***USYD CENTRAL BUILDING, DARLINGTON  
CAMPUS, THE UNIVERSITY OF SYDNEY  
Proposed by Capital Insight Pty Ltd (on  
behalf of The University of Sydney,  
Campus Property and Services)***

Director-General's Environmental Assessment  
Report  
Section 75I of the  
Environmental Planning and Assessment Act 1979

Figure 6. Level 3 plan

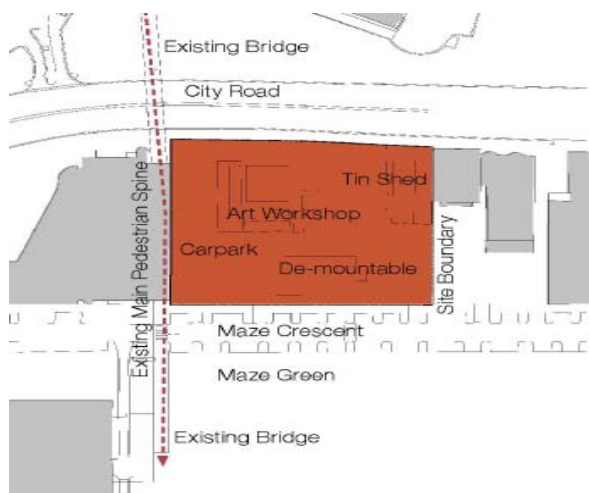
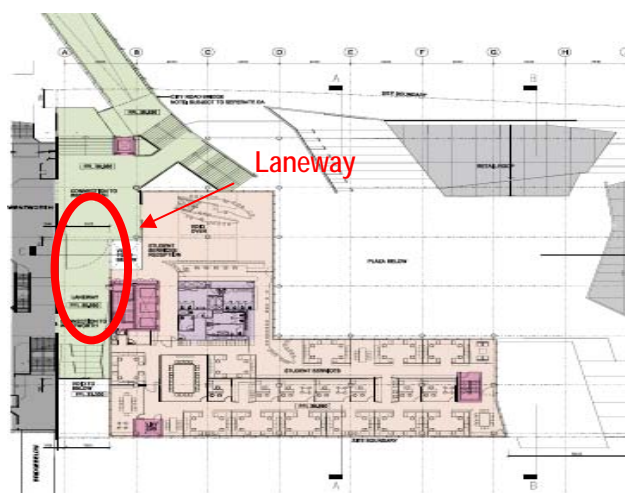
<i>Issue:</i>	The proposed laneway between the USyd Building and the Wentworth Building is considered to be potentially dangerous outside of normal working hours.
<i>Raised by:</i>	Urban Assessments
<i>Consideration:</i>	<p>The proposal creates a laneway space on Level 3 which links the proposed building to the Wentworth Building but does not, at the southern end of the building, provide direct access to Maze Crescent (refer to Figures 5 and 6). Access to Maze Crescent from the laneway is to be via internal passage within the proposed building.</p> <p>The laneway is intended to accommodate queuing students accessing student services at peak times in the University calendar in a way that does not disrupt the general flow of pedestrians through the University.</p>

The design of the laneway is such that it results in a potentially unsafe area, particularly after normal working hours (when access to the Wentworth Building from the proposed building is closed). Closure of the laneway after normal working hours would seek to rectify these concerns. In order to achieve this, access from the pedestrian bridge to the laneway would need to be restricted.

The Proponent's Crime Prevention through Environmental Design Report (CPTED) for the proposed building (Appendix S of EA) acknowledges that the Aria Laneway is potentially dangerous after hours when the entrances to the Wentworth Building are closed. Options put forward by the Proponent to address the issue include installing a gate at the entrance to the laneway or a lightweight barrier (such as a chain) to advise pedestrians that the area is closed. This would be complemented with signage to ensure pedestrians are directed away from the area after hours and the other CCTV measures installed within the building to address safety.

**Resolution:** These options address the concern and have been reinforced by way of conditions requiring specific details of the design, location and management of the device to be installed to be submitted to the Department.

Figure 7. Pedestrian links and access to USyd Central

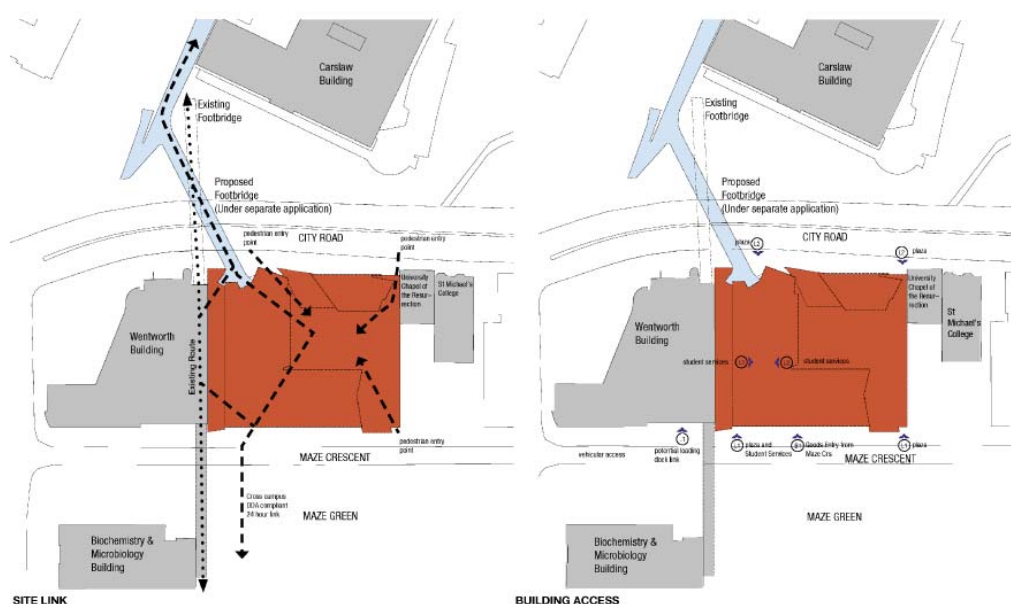
**Consideration:** In responding to this issue, the Proponent has advised that "the pedestrian patterns offer the greatest possible flexibility for pedestrian movement in and from the two street frontages of City Road and Maze Crescent, the plaza, the student services entry and the connection to the Wentworth Building". Figure 7 details the main pedestrian linkages between the Camperdown and Darlington Campuses via the proposed building.

Furthermore, floor levels of the proposed building have been dictated by those in the Wentworth Building to achieve level access between the two buildings. Any proposal on the site is constrained by the topography of the site which varies by more than 6 metres from City Road to Maze Crescent. In aligning the more active parts of both buildings, the design will encourage pedestrian flows to Levels 2 and 3 of the Wentworth Building thereby enhancing the ongoing viability of the Wentworth Building.

The design of retail outlets on Level 2 will require pedestrians to pass by the variety of tenancies in order to exit to either street. The use of signage will be crucial to ensuring pedestrians are directed into and through the building, and are aware of the location of and number of exits.

**Resolution:** It is acknowledged that the existing site constraints have led to a complex internal planning solution. This matter was subsequently explored at length with the Proponent who has advised that the current design is the best outcome. The installation of way-finding signage in combination with the proposed differentiated paving will direct pedestrians into, through and out of the building.
